DATE: February 5, 2026

ADDENDUM NO. 5

PROJECT NO. DGS C-0946-0012 PHASE 006
PROJECT TITLE - PA State Museum & PHMC Tower - Infrastructure Upgrades and Renovations
PROFESSIONAL:
Design Resources Group Architects AIA
270 Davidson Ave, Suite 303
Somerset, NJ, 08873

FILE PATH: X:\Projects\Harrisburg\949_00\Archive\AD_AD103_Museum_Floor 03_DEMO.dwg
LAST SAVED: 26.01.14 03:55 PM
PLOTTED: 26.01.14 09:17 AM
PLOTTED BY: CLOSE

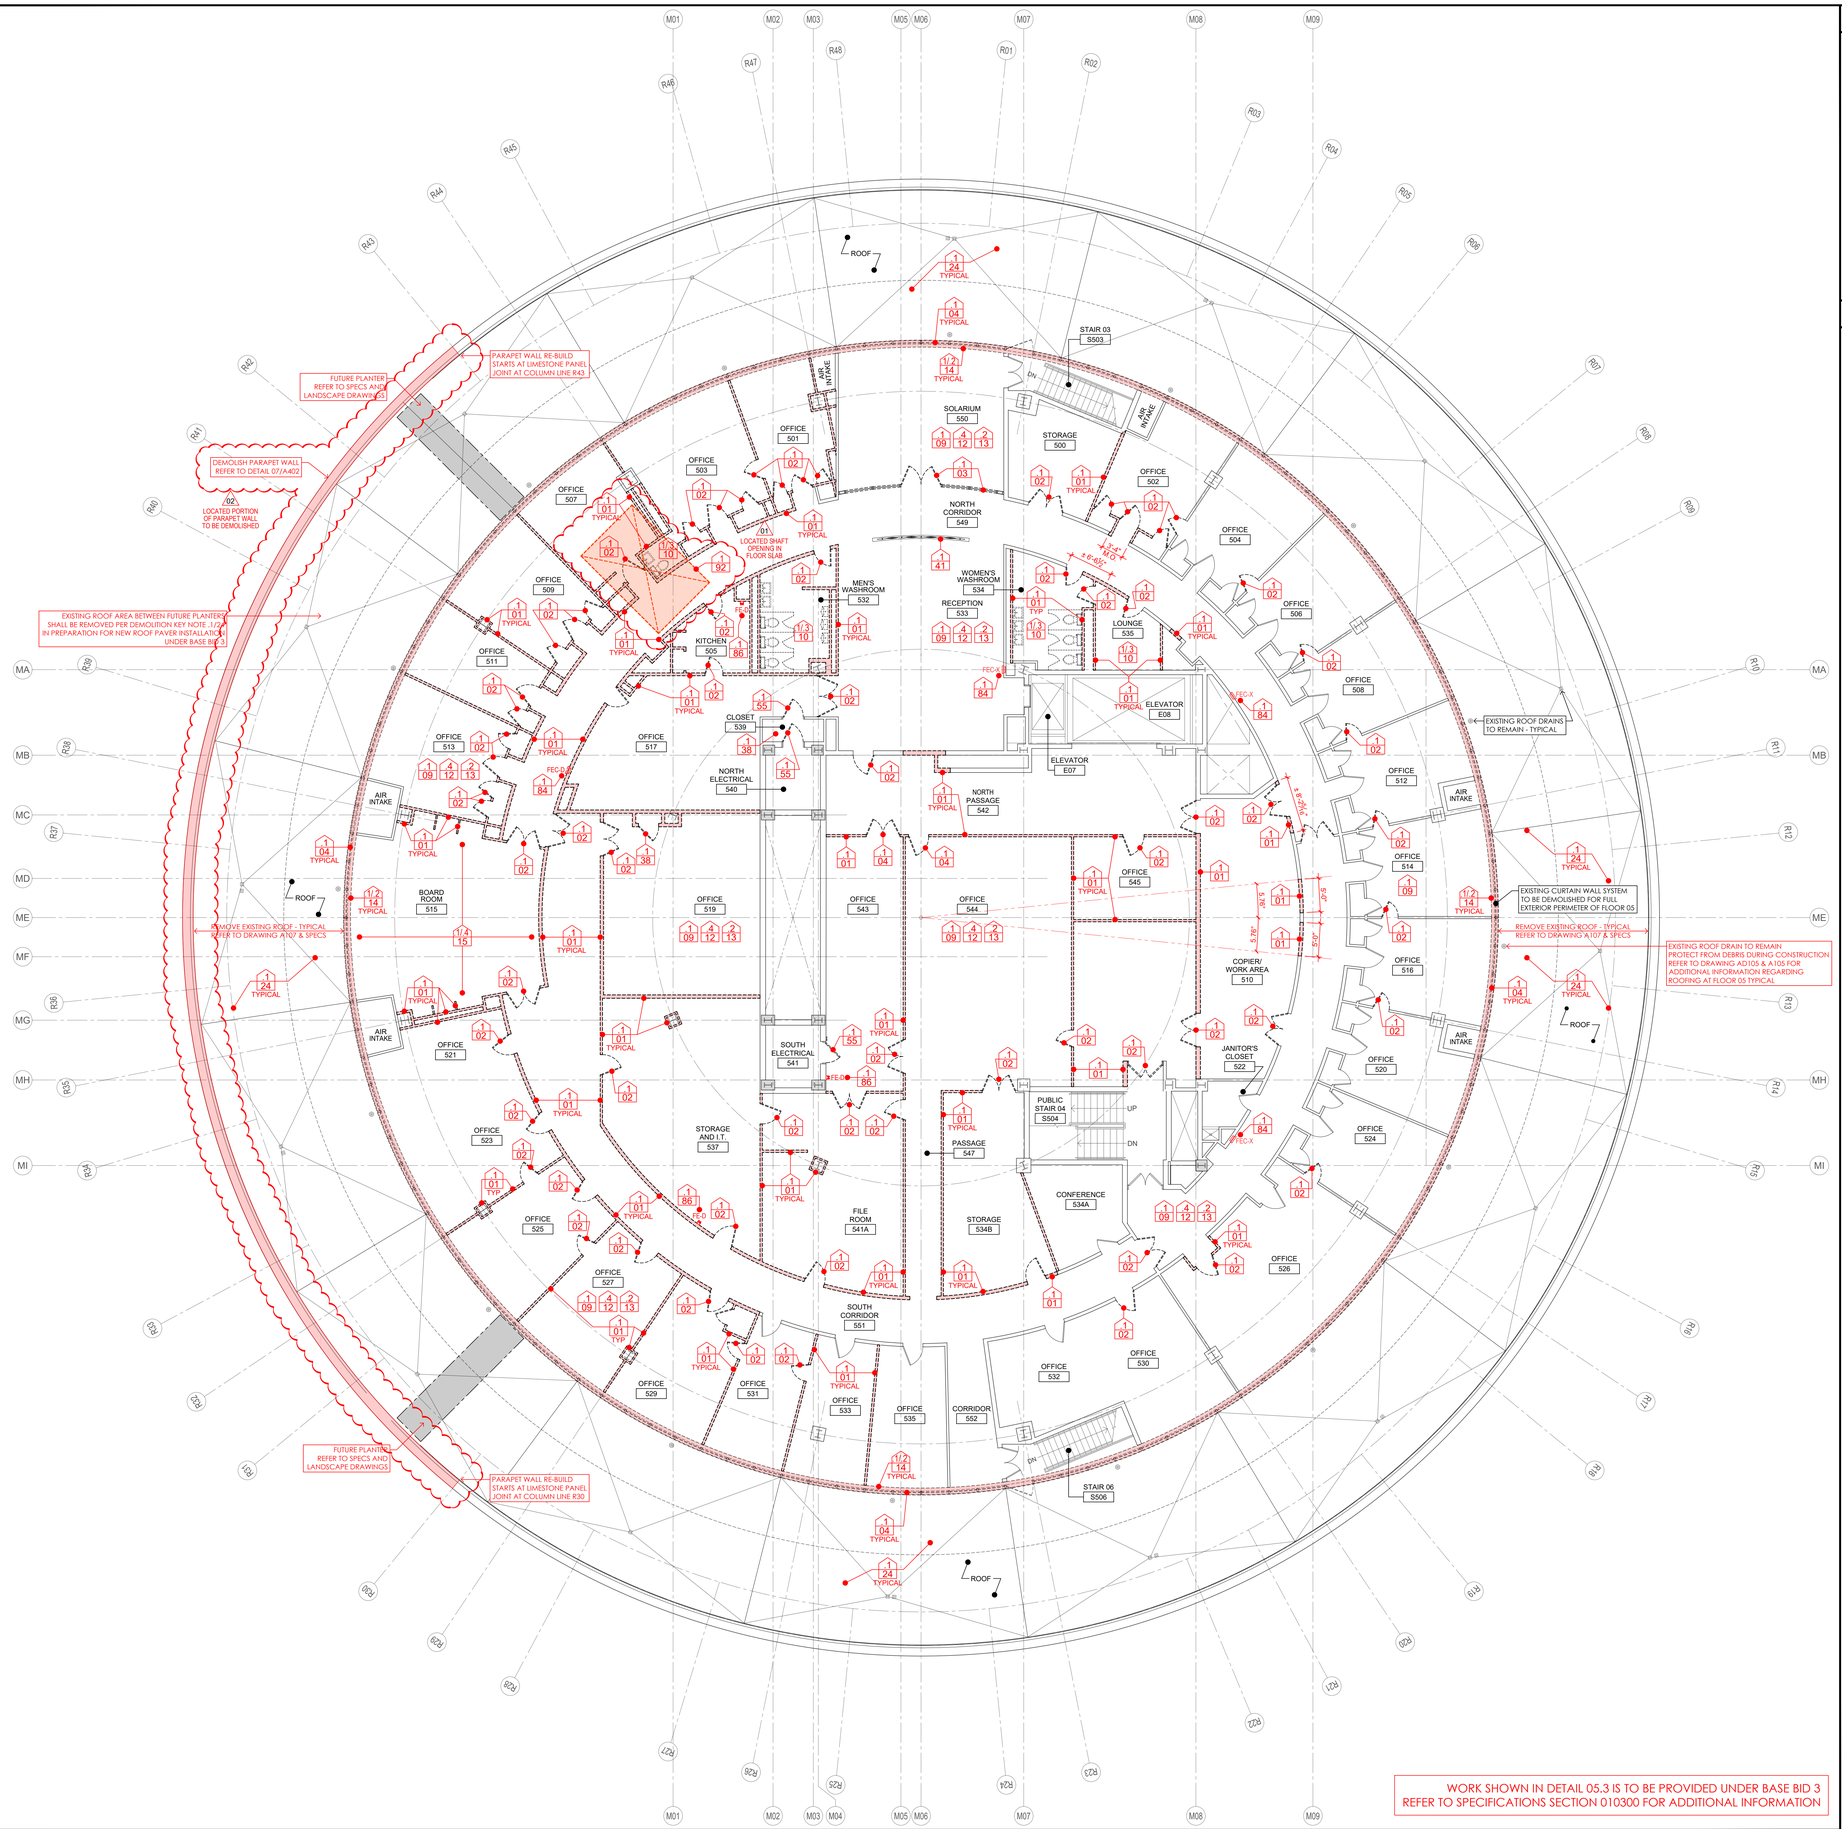
Item 1 - Drawing AD103 - Added note at Ecology 3028 to indicate that all components of the display cases are to be demolished and disposed of. No materials are to be salvaged.

STATE MUSEUM - GROUND FLOOR - PART 01 - ARCHITECTURAL RENOVATION PLAN 0G.1

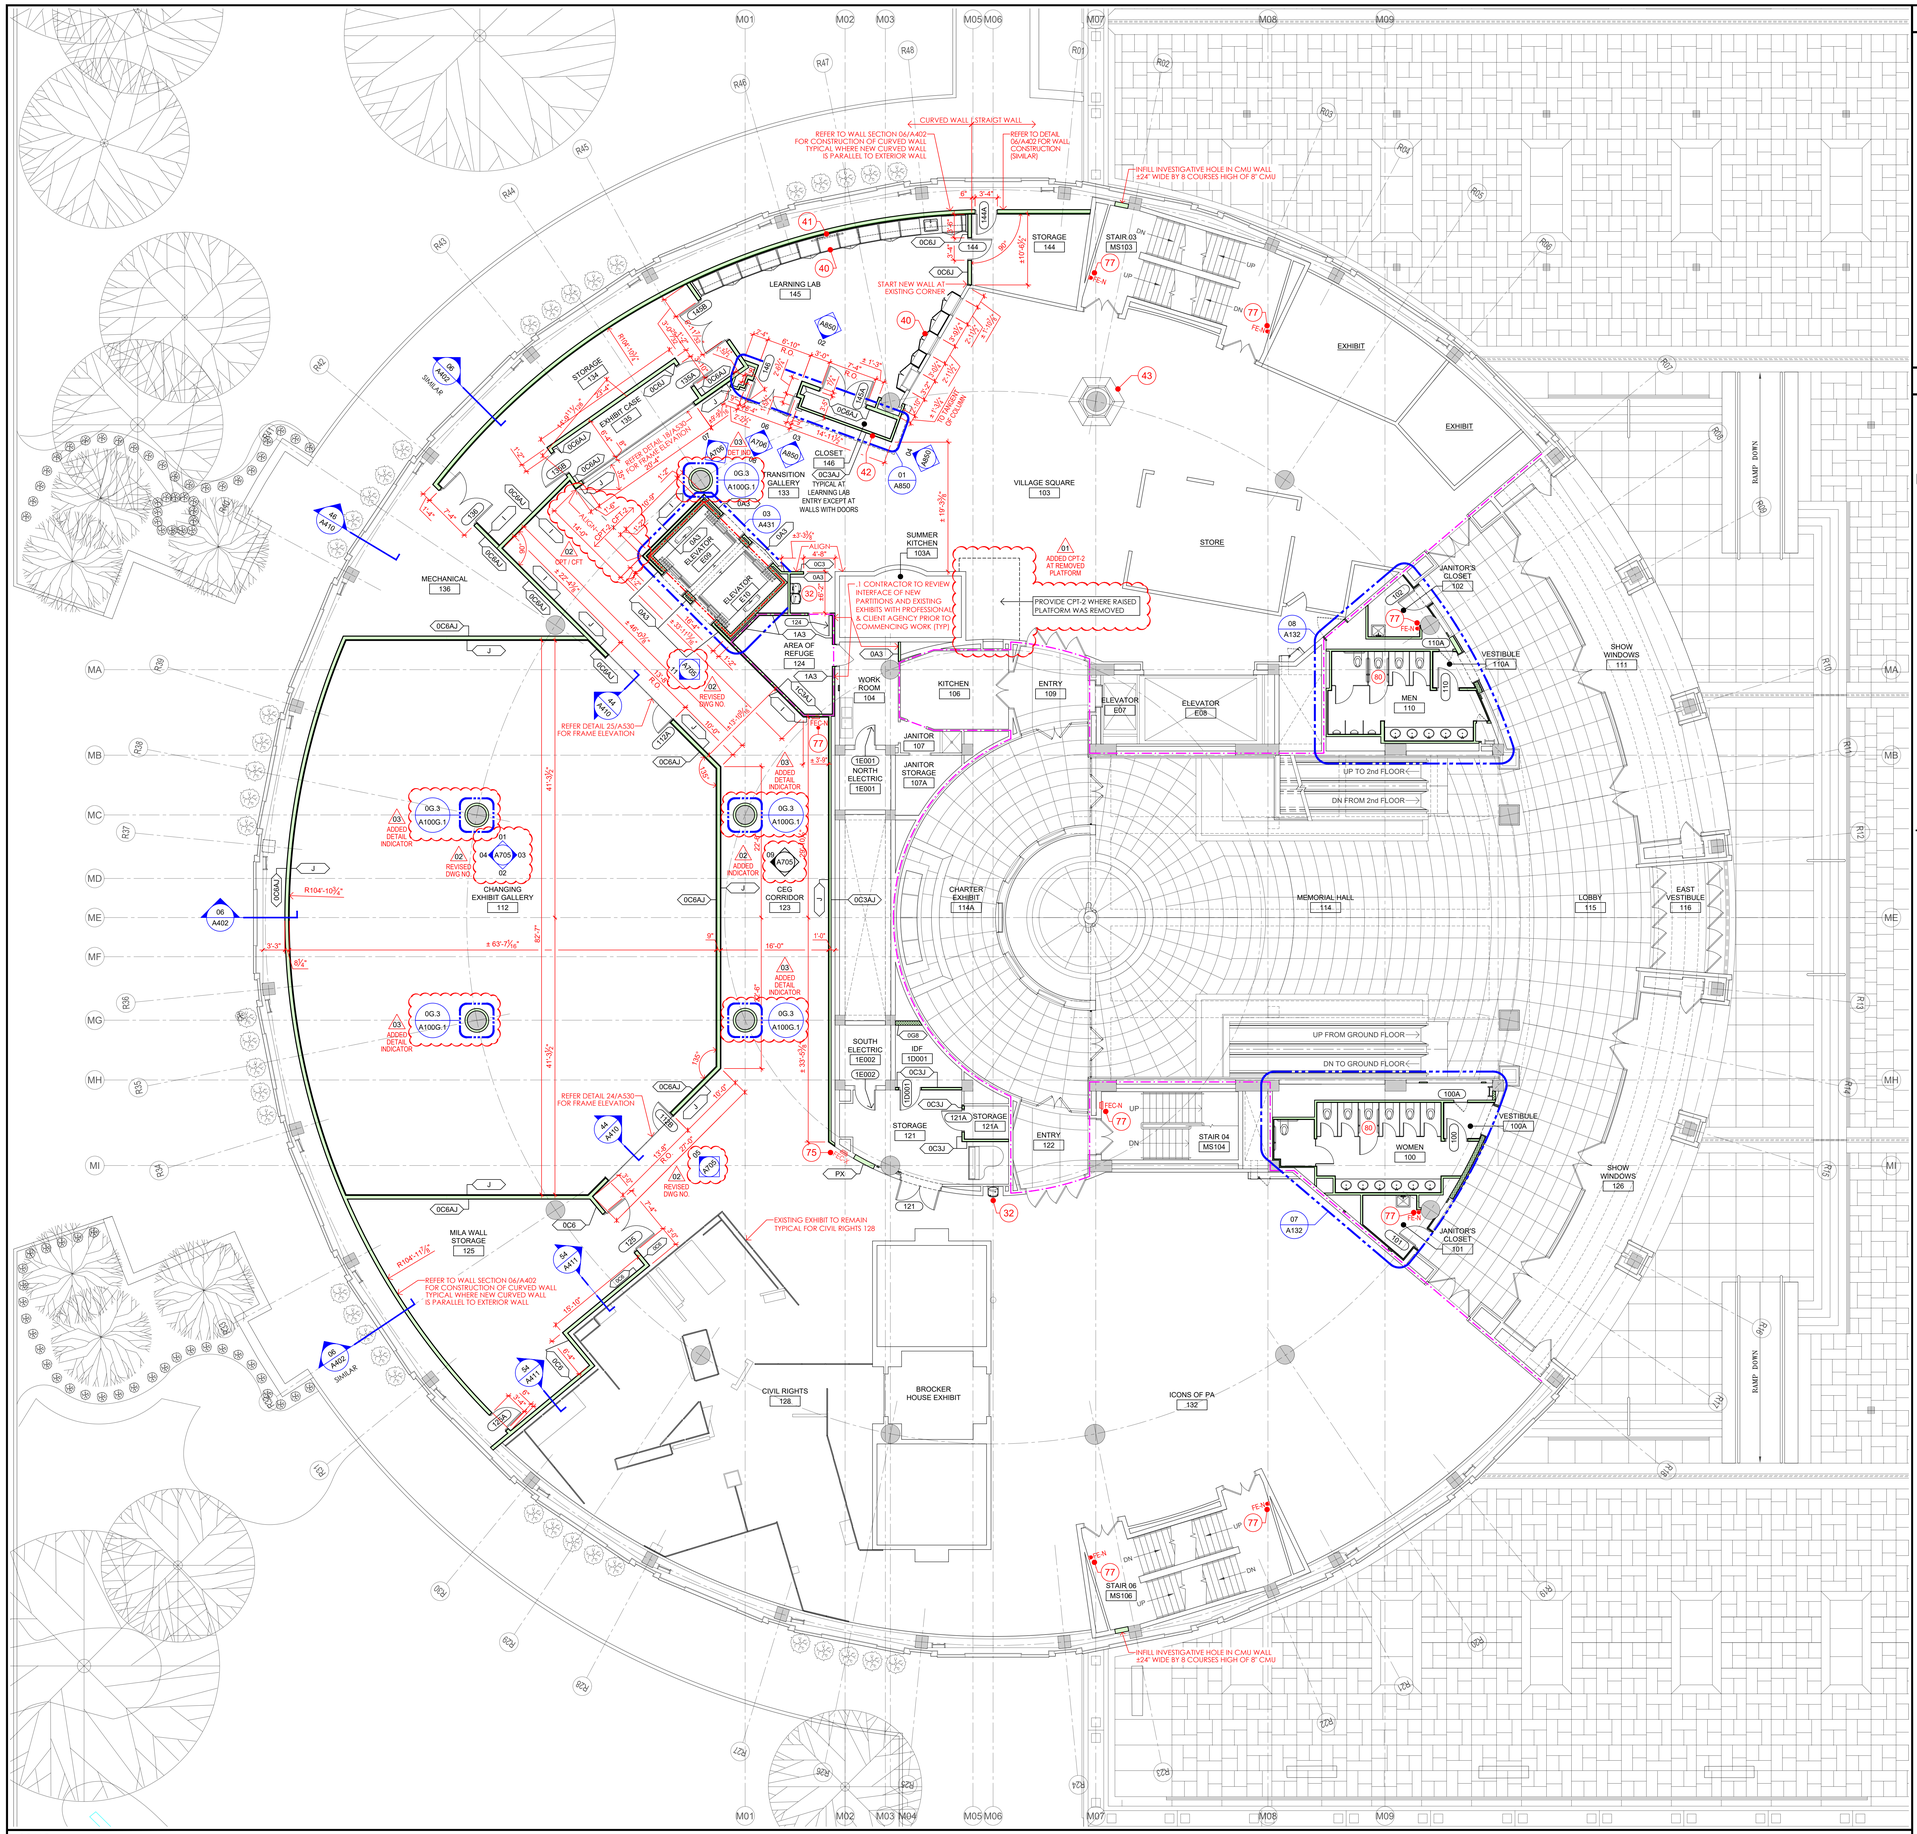
Item 4 - Drawing A100G.1 - Added detail indicator for all columns requiring column wraps.

FILE PATH: X:\Projects\Harrisburg\6403_00\BIDS\6403_A101B_Museum Floor 01_RENO.dwg
PLOTTED: 10.10.2025 12:11 PM
LAST SAVED: 10.10.2025 12:11 PM
PLOTTED BY: CLOSE

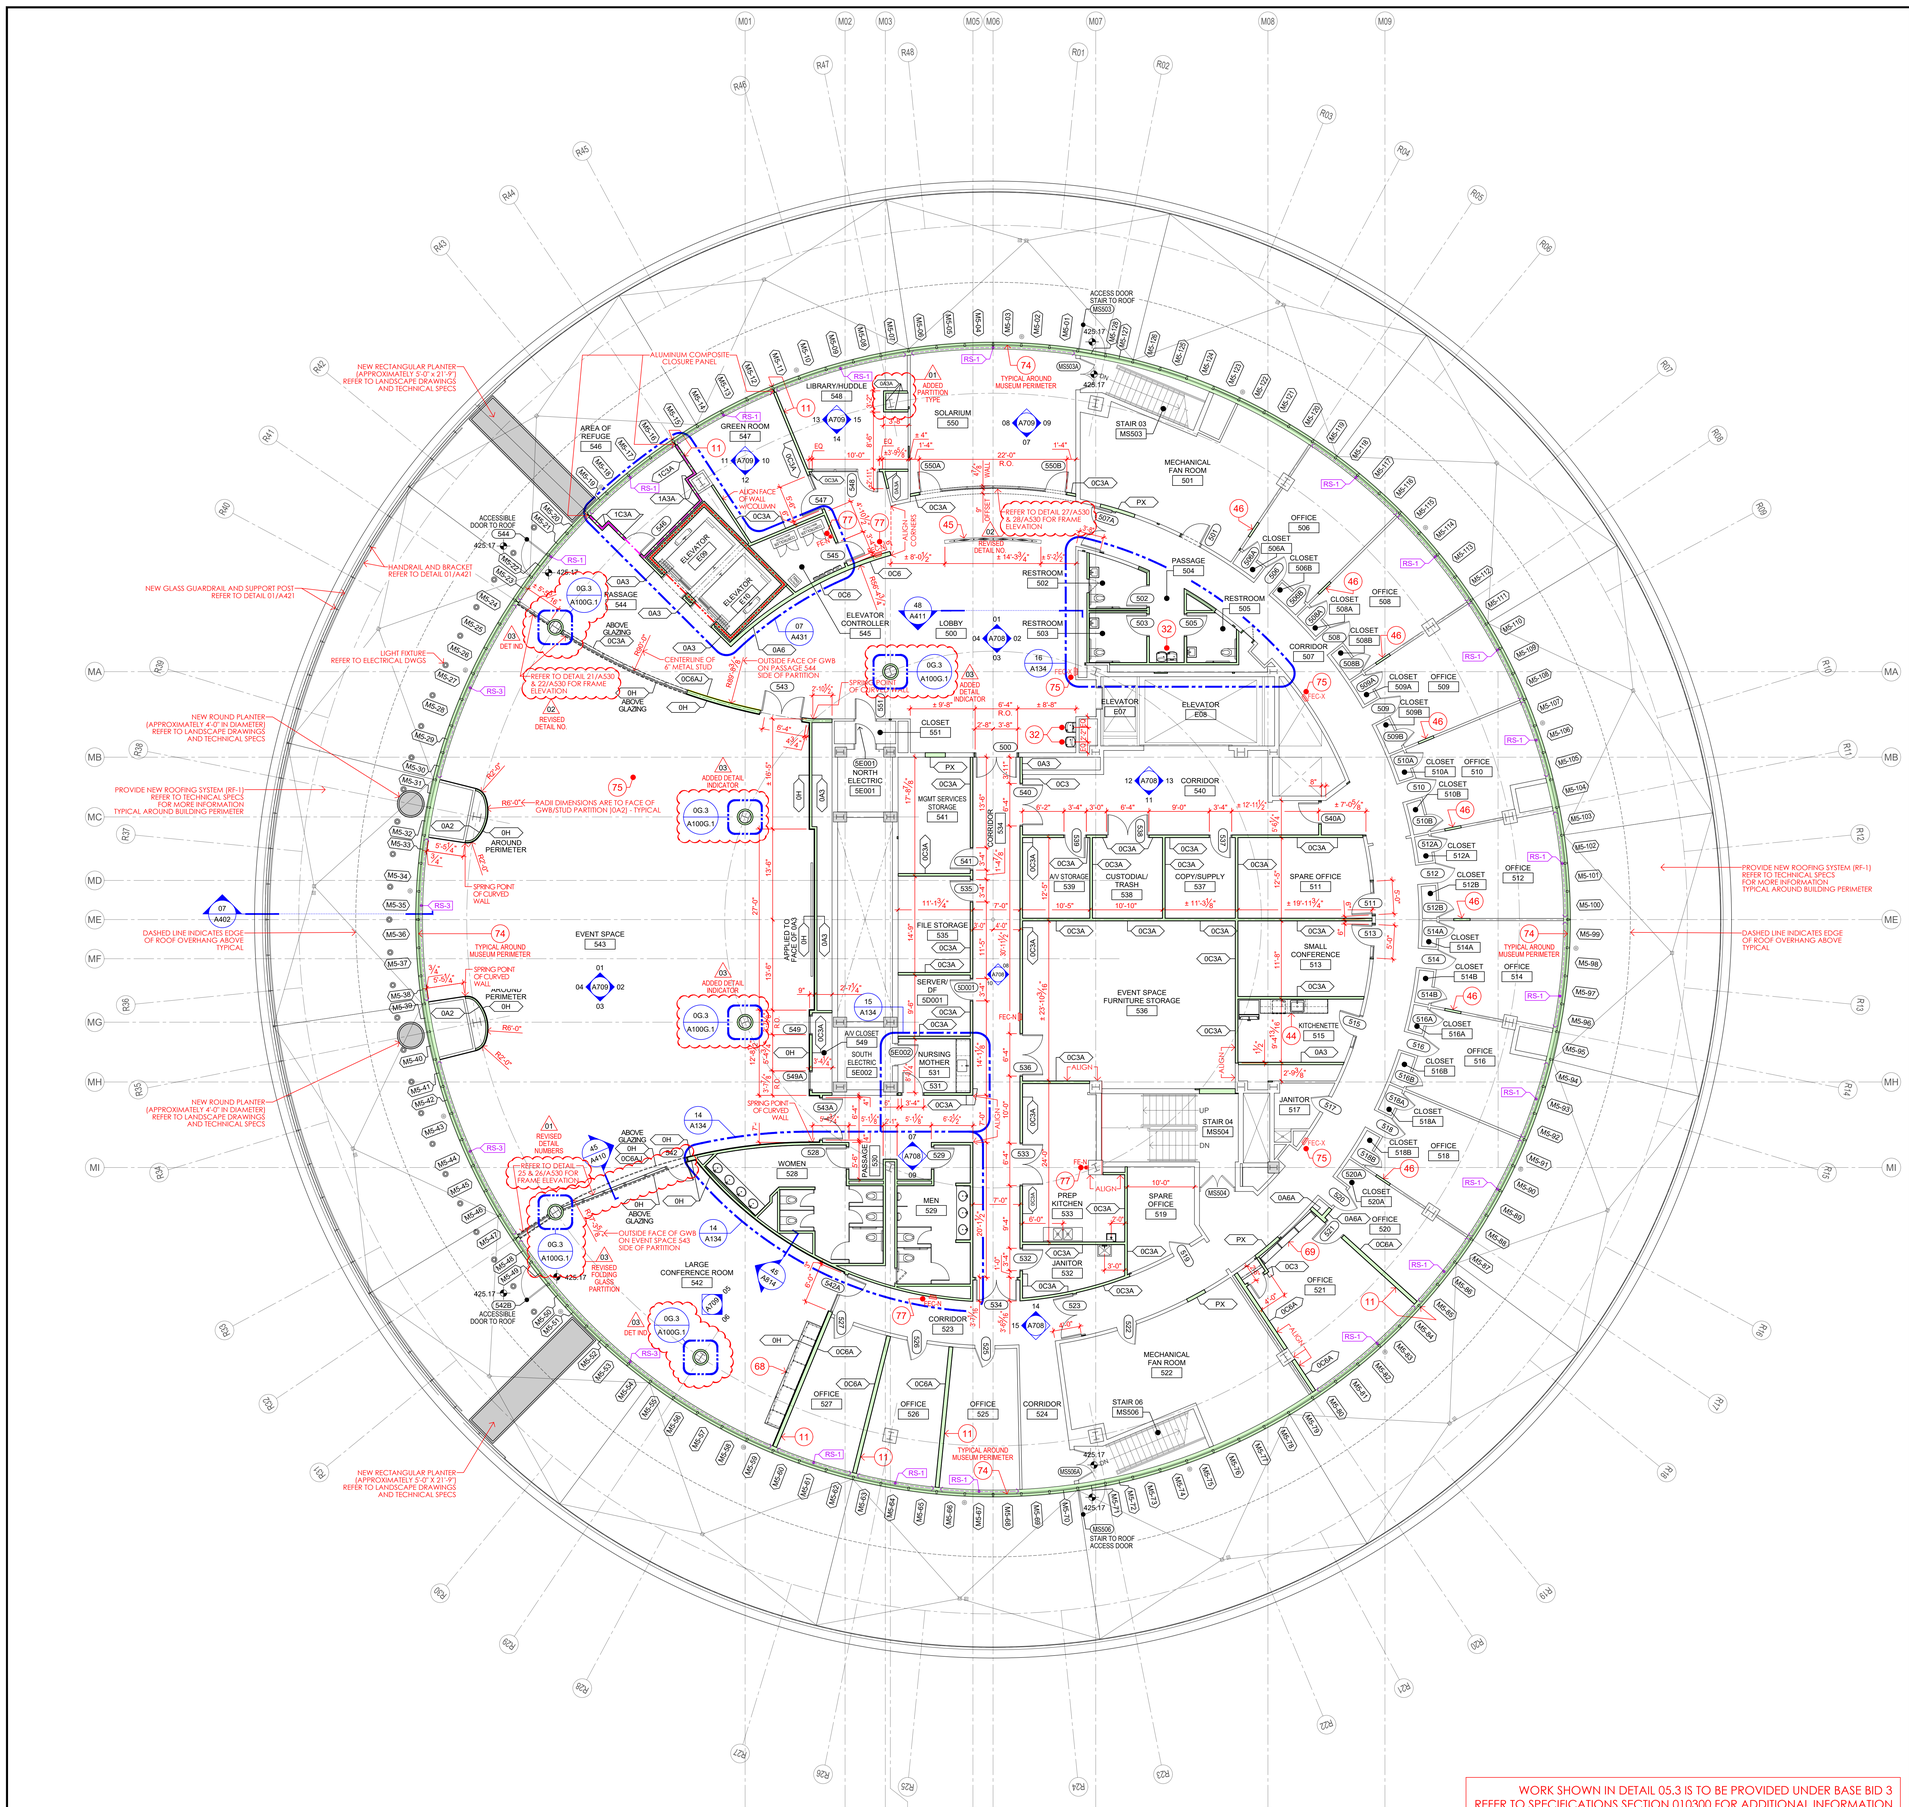
Item 5 - Drawing A101B - Added detail indicator for all columns requiring column wraps.
